Access Compliance Report

Public Rights-of-Way

(Curb Ramps)

Intersection ID: 54772	Main Street: SARDIS_RD_NORTH	Cross Street: NOLLEY CT	Location: SW
ADA ID: F0576CC3FB29	Ramp Type: PerpDiag	Initial Pass/Fail: Fail	Overall Compliance: No
Severity Score: 21.25			
Codes/Mitigation Info/Possible Solution		Field Measurements/Component Compliance

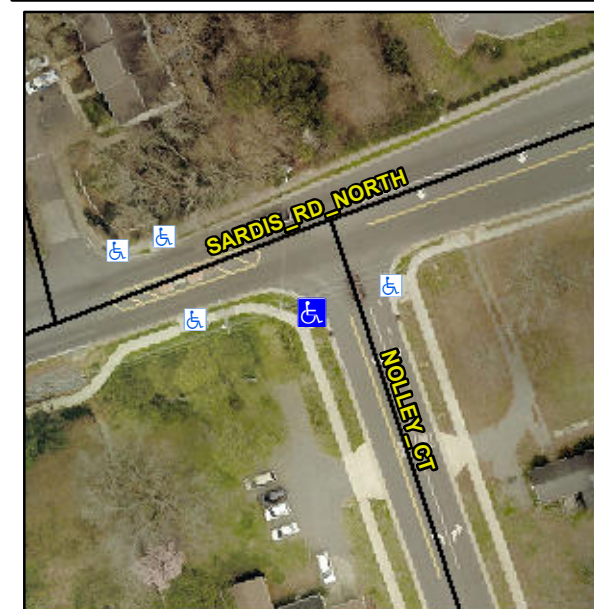
R304.5.1, R304.5.3

Compliance	Description	Data	Compliance	Description	Data
N/A	Ramp Length (in)	96.0	Yes	Ramp Slope (%)	6.1
No	Ramp Width (in)	44.0	No	Ramp XSlope (%)	5.1
N/A	Flare Type LT	N/A	N/A	Flare Type RT	N/A
N/A	Flare Slope LT (%)	N/A	N/A	Flare Slope RT (%)	N/A
N/A	Flare Traversable LT?	N/A	N/A	Flare Traversable RT?	N/A
N/A	Landing Length (in)	N/A	N/A	DWS Provided?	N/A
N/A	Landing Width (in)	N/A	N/A	DWS Contrast?	N/A
N/A	Landing Slope (%)	N/A	N/A	DWS Length (in)	N/A
N/A	Landing X Slope (%)	N/A	N/A	DWS Full Width?	N/A
N/A	Landing Curb? (Y/N)	N/A	N/A	DWS Offset (in)	N/A
N/A	Shared Landing?	N/A			
N/A	Gutter Ponding?	N/A	N/A	Gutter Slope (%)	N/A
N/A	Gutter Lip Ht (in)	N/A	N/A	Gutter X Slope (%)	N/A
N/A	Painted X Walk1?	No	N/A	Painted X Walk2?	No
	X Walk 1 Direction	To E		X Walk 2 Direction	To N
N/A	X Walk 1 Width (in)	N/A	N/A	X Walk 2 Width (in)	N/A
	X Walk 1 Slope (%)	1.4		X Walk 2 Slope (%)	2.5
	X Walk 1 X Slope (%)	2.2		X Walk 2 X Slope (%)	0.7

Remove & Replace Curb Ramp With Two New Directional Ramps or Equivalent.
